**RE: Responses to USACE February 23, 2018, Data Request  
New England Clean Energy Connect Project  
Application for Department of the Army Permit**

**Response to the  
February 23, 2018  
USACE Information Request**

*Prepared for:*  
**Department of the Army**  
**New England District, Corps of Engineers**  
**Application No. NAE-2017-01342**

**Attachment B: Kennebec River Gorge Photosimulations**

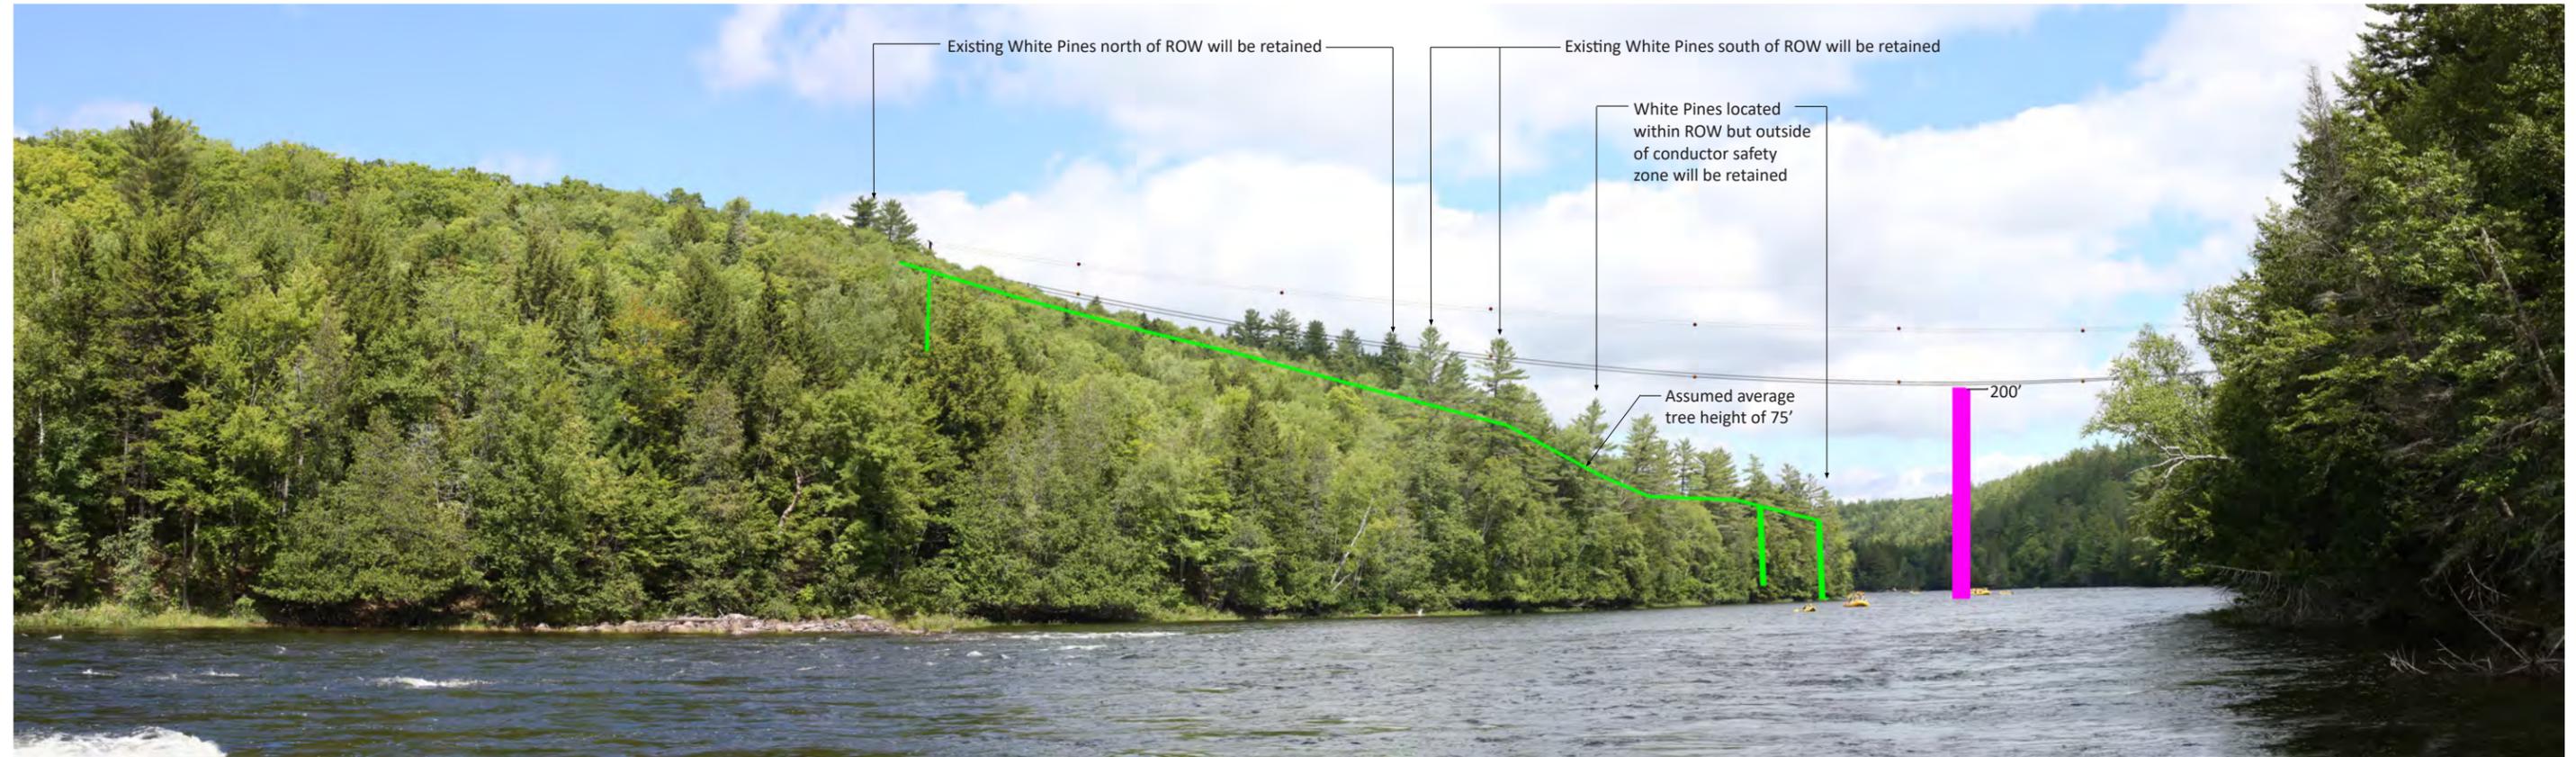
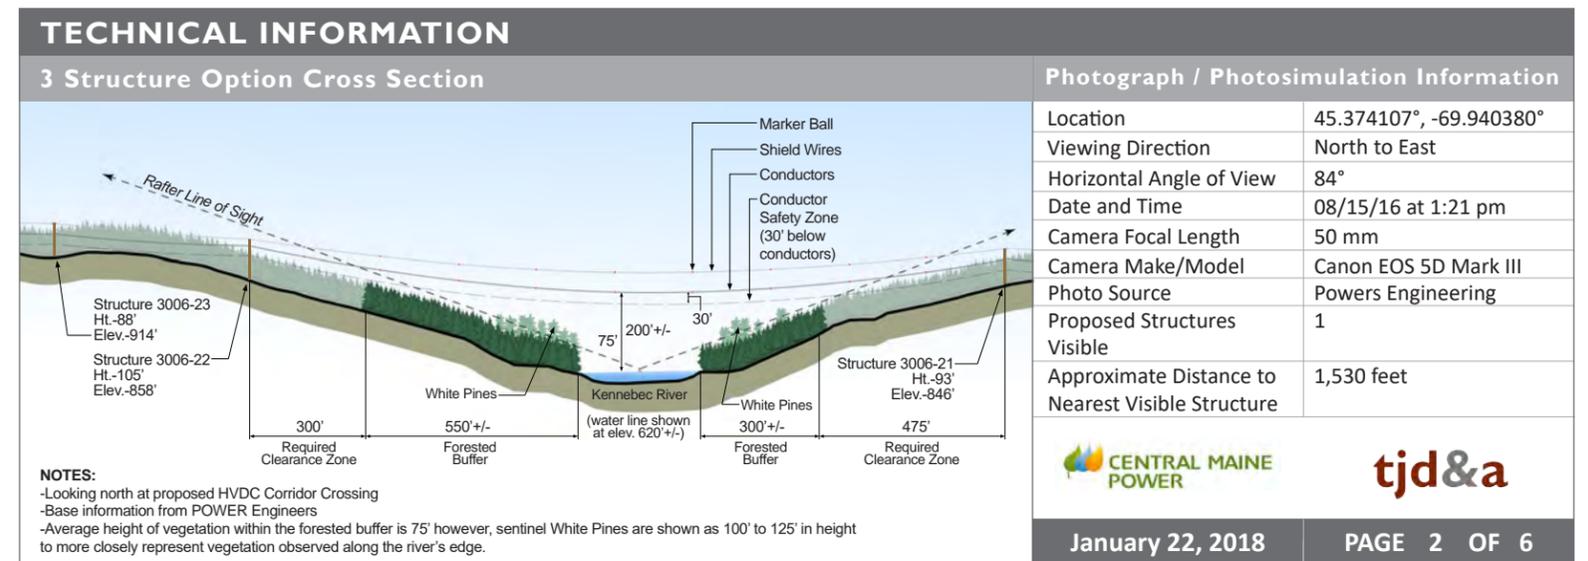
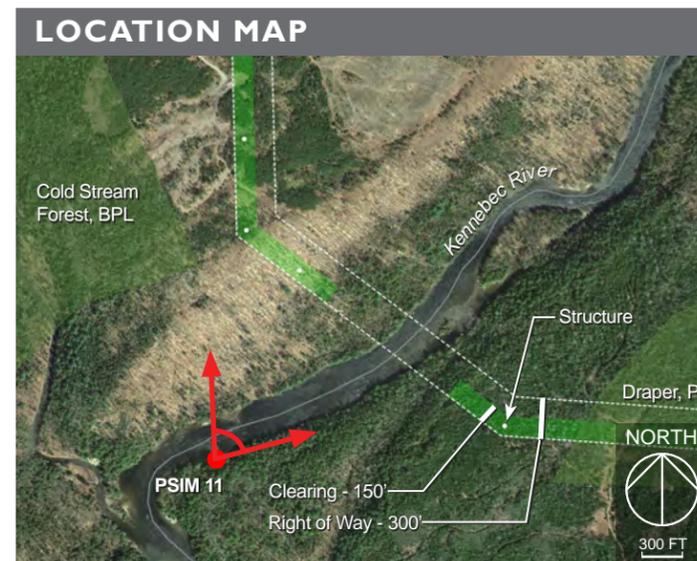
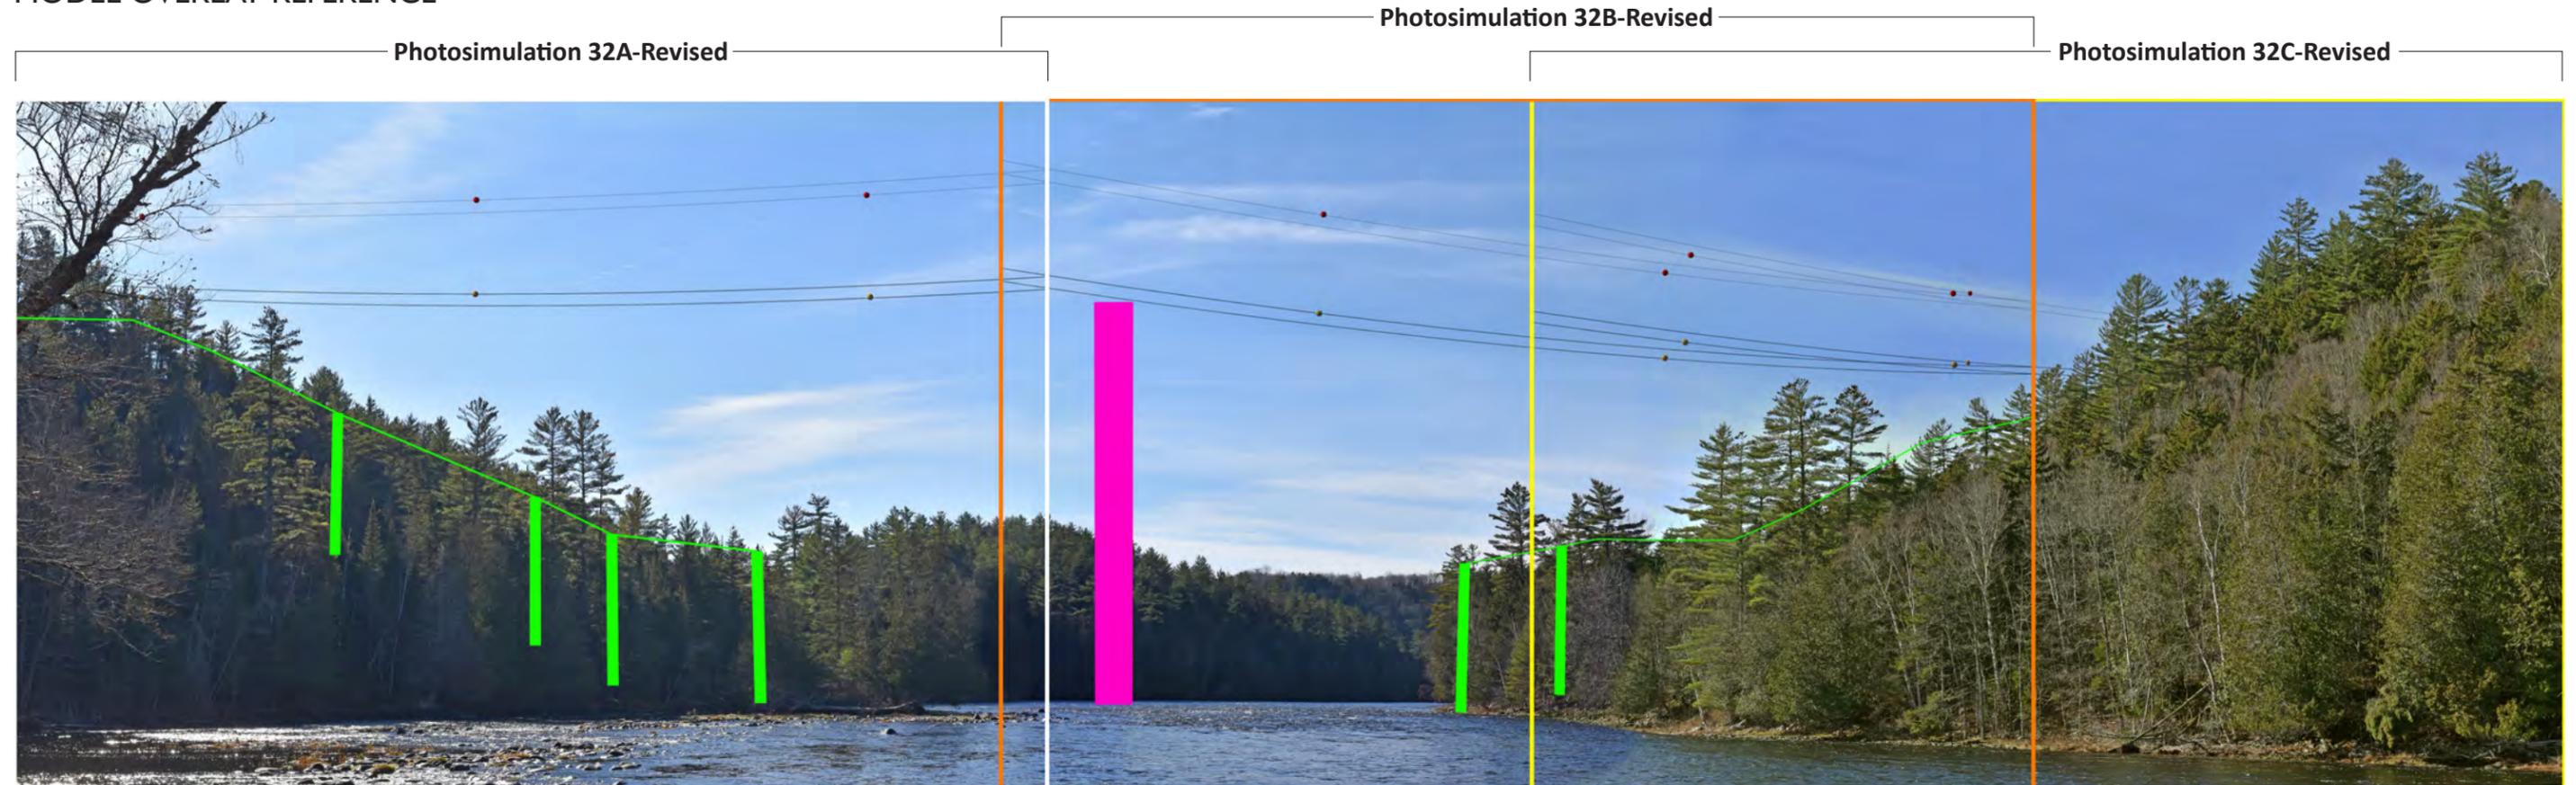
**7. Section 2.4.1.2, Kennebec River Gorge. Please confirm that the updated crossing designs and photo sims transmitted in your December 12, 2017 email are the most current (in view of our interagency site visit and any subsequent coordination you've had with DEP and LUPC staff). Is there any updated discussion of the directional drill alternative at this location we should be aware of?**

Upon further conversations with LUPC, CMP is providing revised photosimulations, dated January 22, 2018, which is an update to the December 12, 2017 photosimulations. The updated photosimulations are of the 3-pole structure redesign, at a "normal view," removing the distortion and providing a more accurate depiction of the conductor sag over the river. Additionally, the mark-up of the panoramic

photos includes overlaid scale references and additional detail of the low point of the conductor sag and the assumed average of the 75-foot existing tree height. See Attachment B: Kennebec River Gorge Photosimulations. At this time, there is no updated discussion of the directional drill alternative at the Kennebec River Gorge.

**New England  
Clean Energy  
Connect**

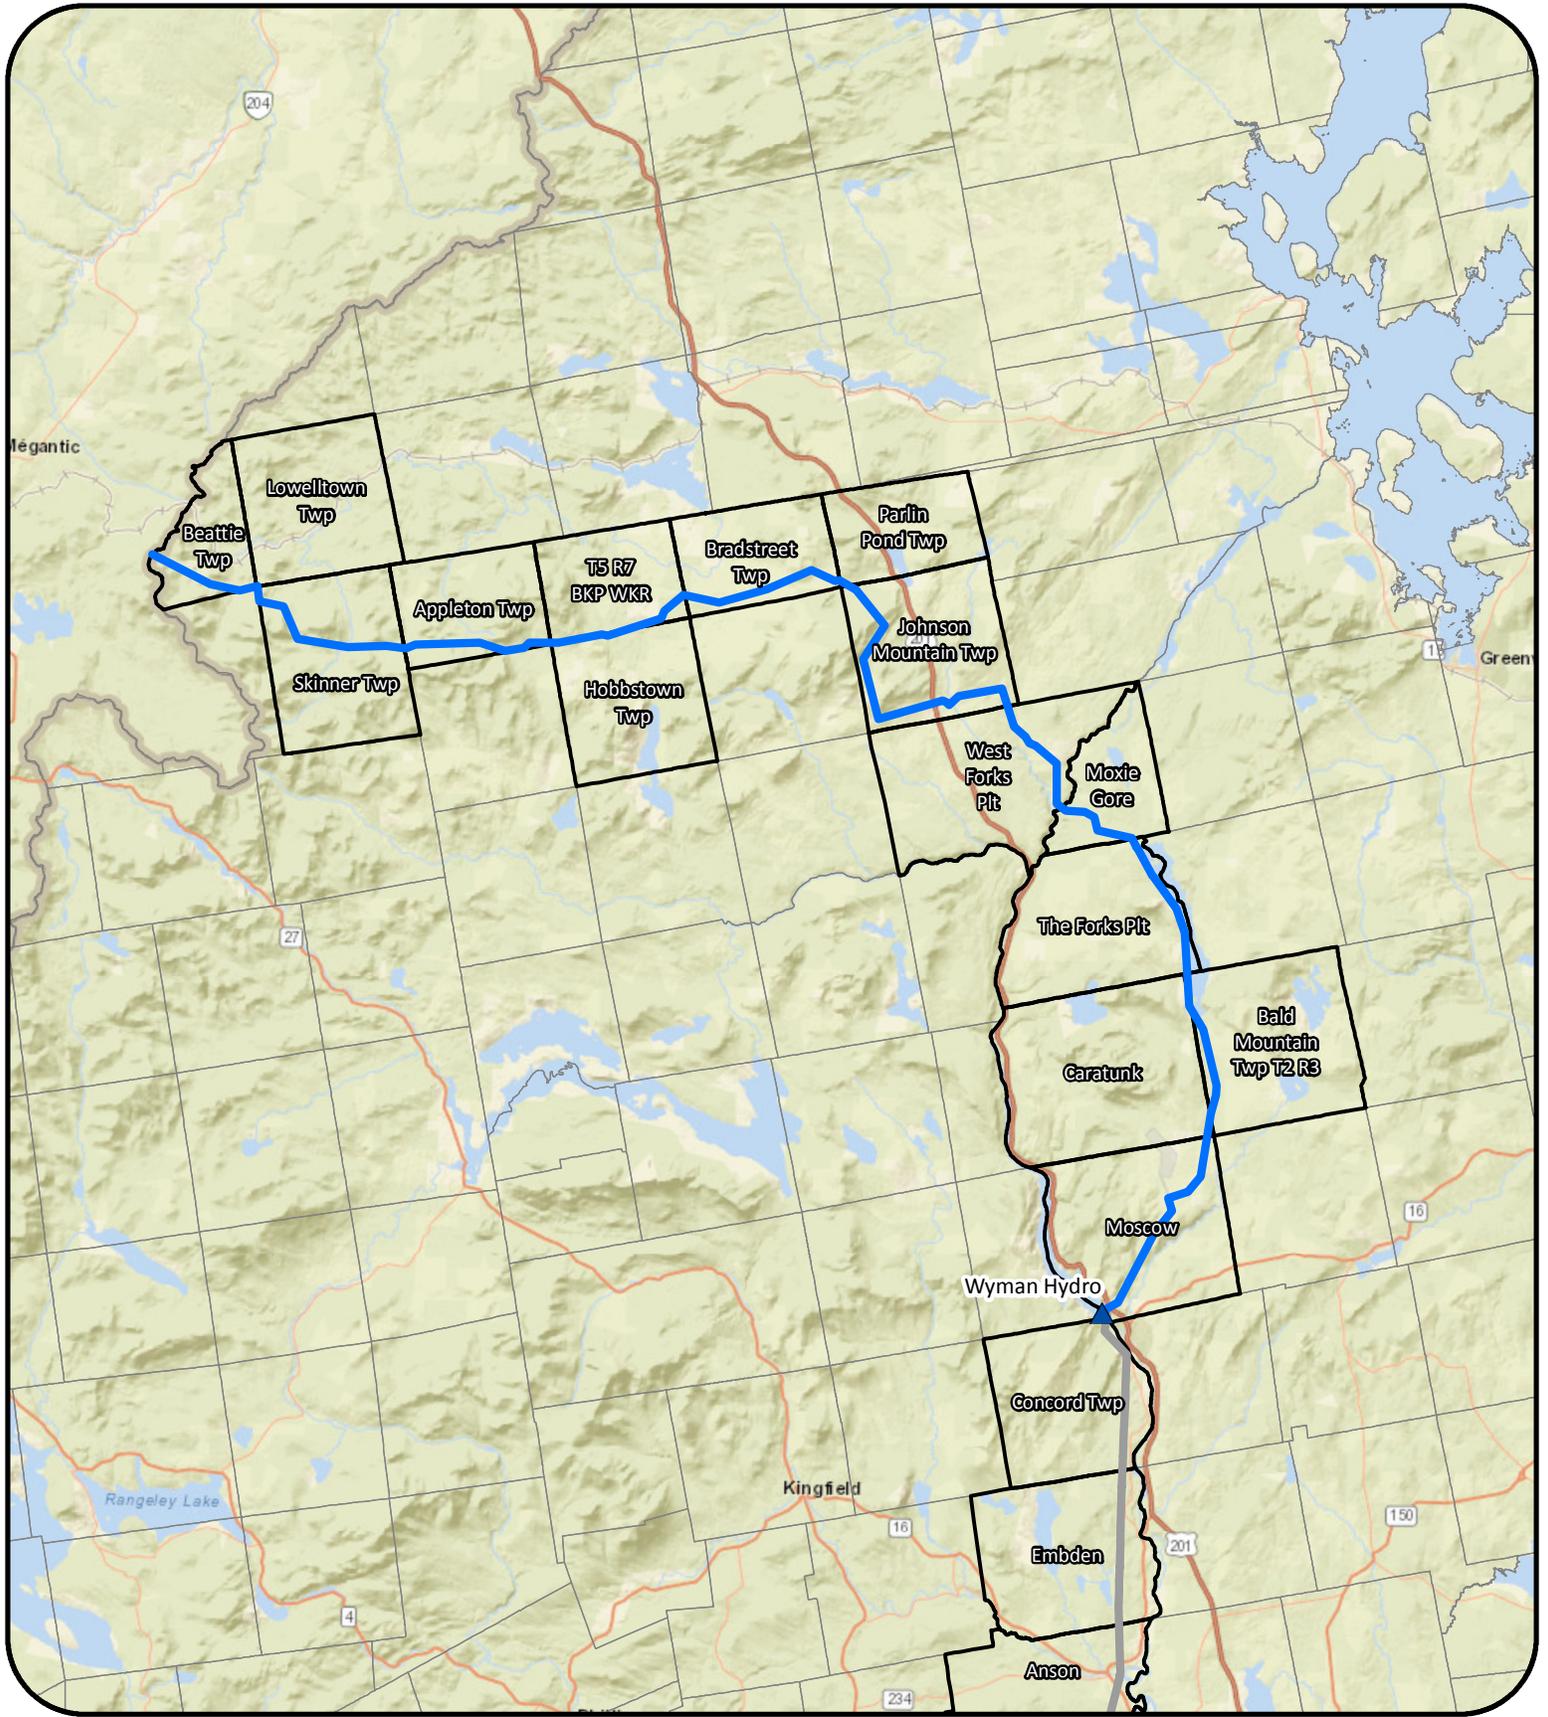
**20. Attachment 1, Plans. Please provide a master plan that shows the whole project route 1) on one sheet relative to the whole state; and b) in a more detailed view. This is for reference purposes in our future public notice.**

Attachment D contains a master sheet that shows the various Project segments in relation to the State of Maine. To provide a more detailed view, we have included area-specific depictions of the Project components on individual pages keyed to the master sheet.

**New England Clean Energy Connect**  
 Natural Resource Maps  
 Segment 2  
 250

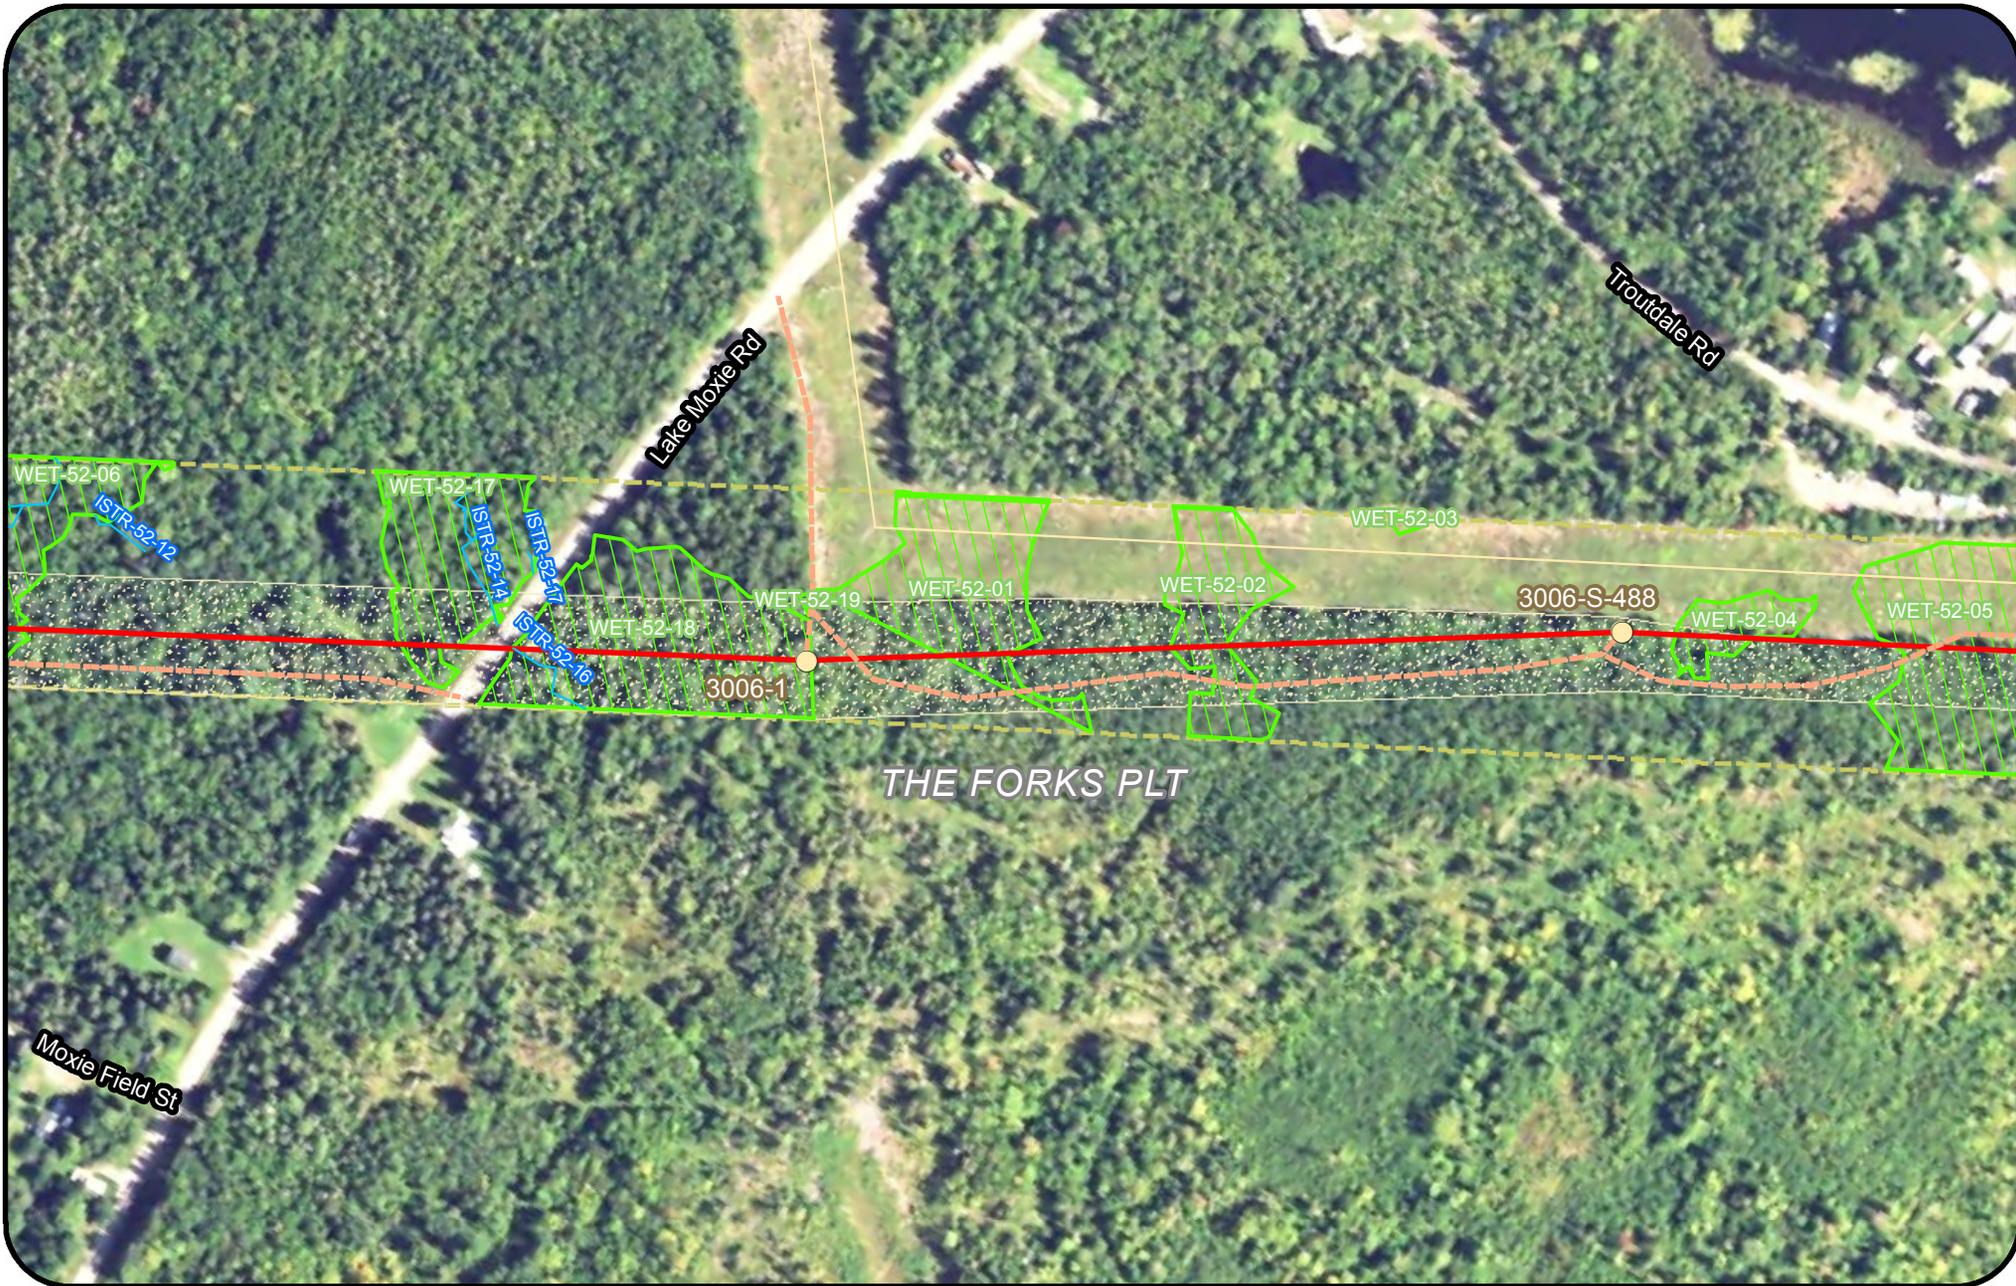
**21. Section maps. Please relabel the section maps with larger font so that they are more legible.**

The section maps, also known as natural resource maps, have been edited with larger font as requested. For reference, an example map page is provided in Attachment D. CMP intends to provide the entire updated map set and updated natural resource impact numbers when the engineered design is 70% complete.
